PDR
EGG-EA-6131

JANUARY 1983

ADEQUACY OF STATION ELECTRIC DISTRIBUTION SYSTEM
VOLTAGES, OCONEE NUCLEAR STATION, UNIT NOS. 1, 2
AND 3

INTERIM REPORT

Figure 1. Onconee Electrical Single Line Diagram - Unit 1

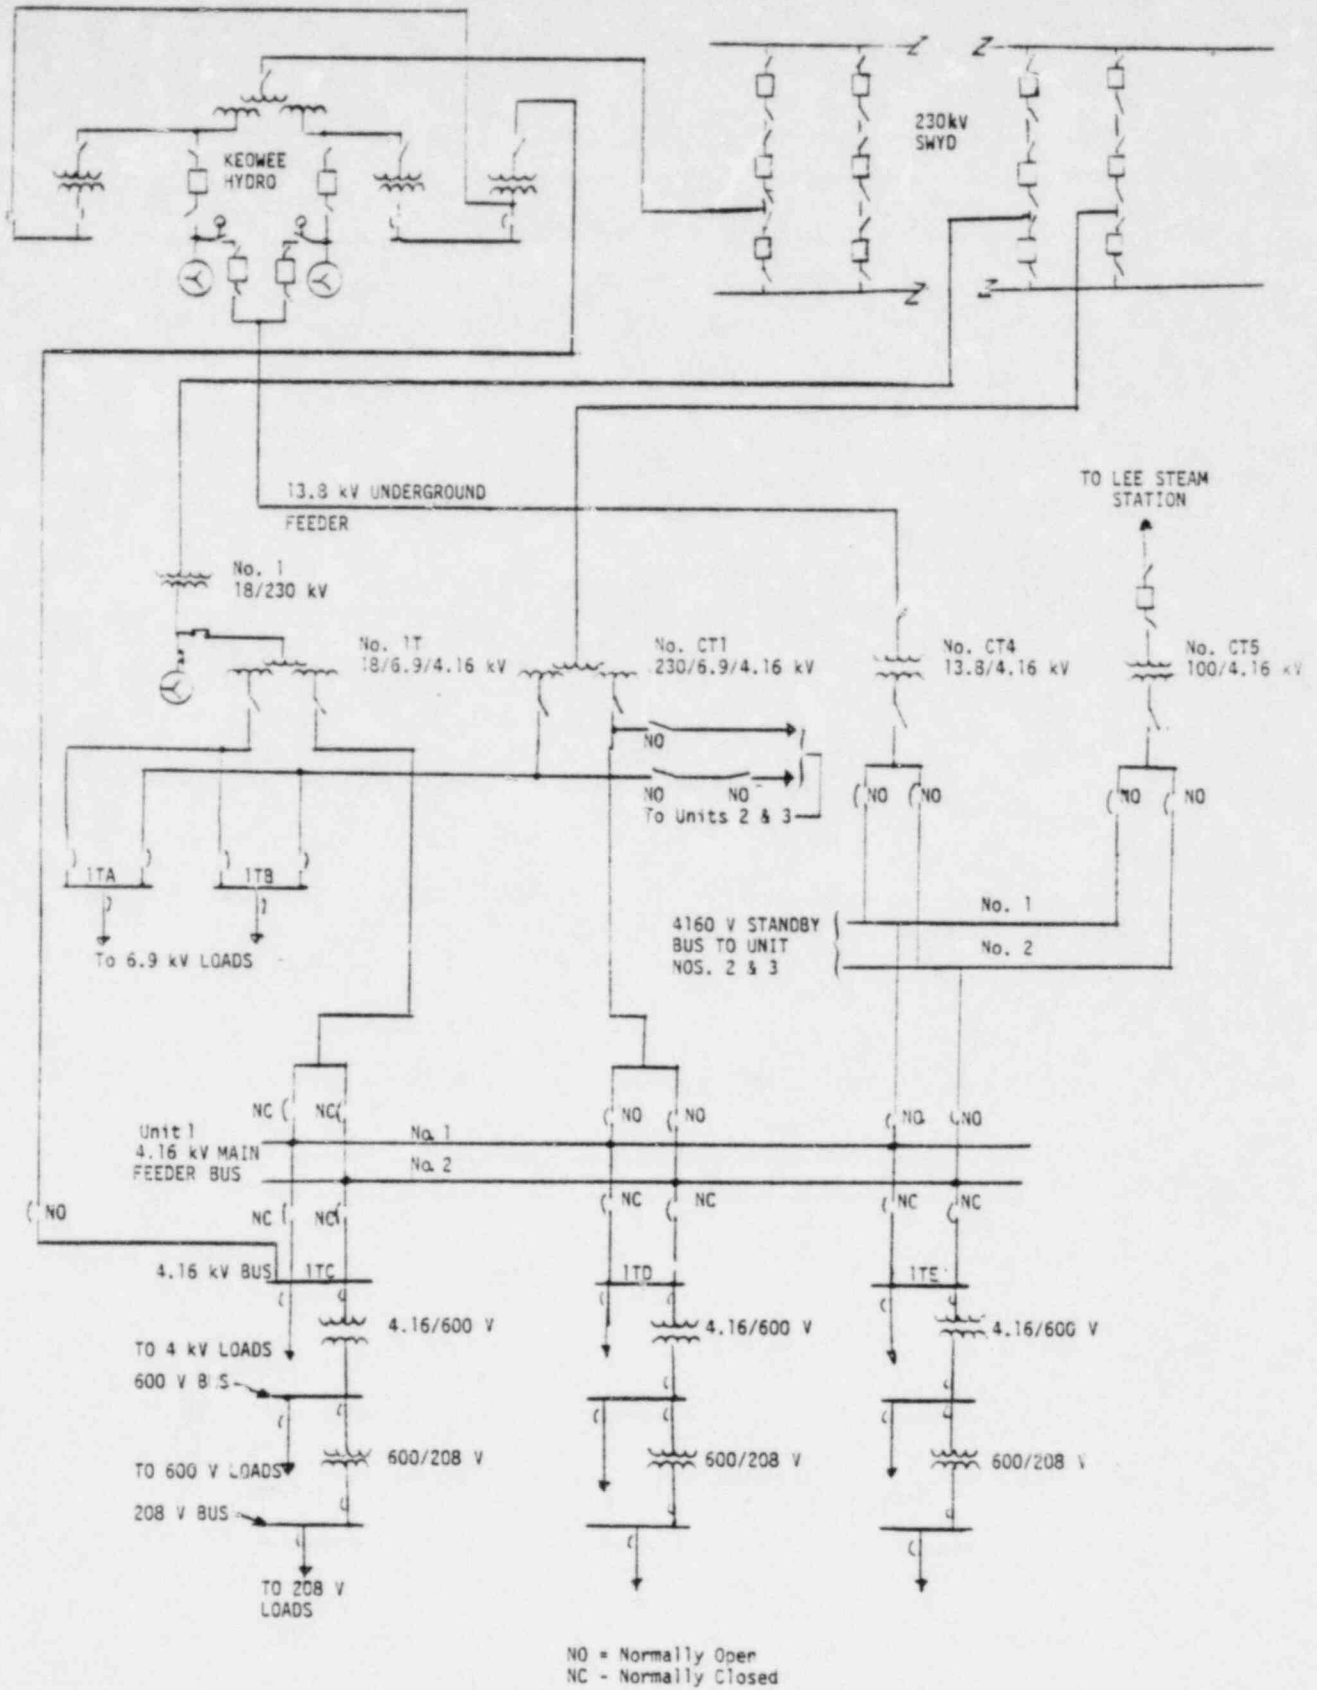
Figure 1 of this report is a simplified sketch of the Oconee electrical single-line diagram. The following description pertains to Unit 1. Unit Nos. 2 and 3 are similar.

During normal plant full-power operation, auxiliary power is supplied by the unit auxiliary transformer No. 1T and during startup and shutdown, by the startup transformer No. CT1 via the 230kV switchyard. Provisions are made for automatic fast transfer of the auxiliary loads from the unit auxiliary transformer to the startup transformer on a unit trip. A second

independent circuit is available from the 230kV switchyard (525kV switchyard for Unit No. 3) to the onsite distribution system via the main transformer and the unit auxiliary transformer for that unit when the main generator bus disconnect links have been removed. Complete loss of all offsite power will result in the automatic transfer to either of the two onsite Keowee hydroelectric generators which are capable of supplying all the emergency and shutdown loads via CT4. Emergency and shutdown loads can also be supplied from a gas turbine generator at the Lee Steam Station via CT5. This generator is isolated from the grid and is considered an onsite source.⁶

There are three essential 4.16kV buses; No. 1TC, 1TD, and 1TE. One division of safety-related equipment is powered from each of these buses. Each bus supplies 4kV loads, the 600V load centers and motor control centers (MCCs), and, in turn the 208V MCC's and the 125/250VDC systems.
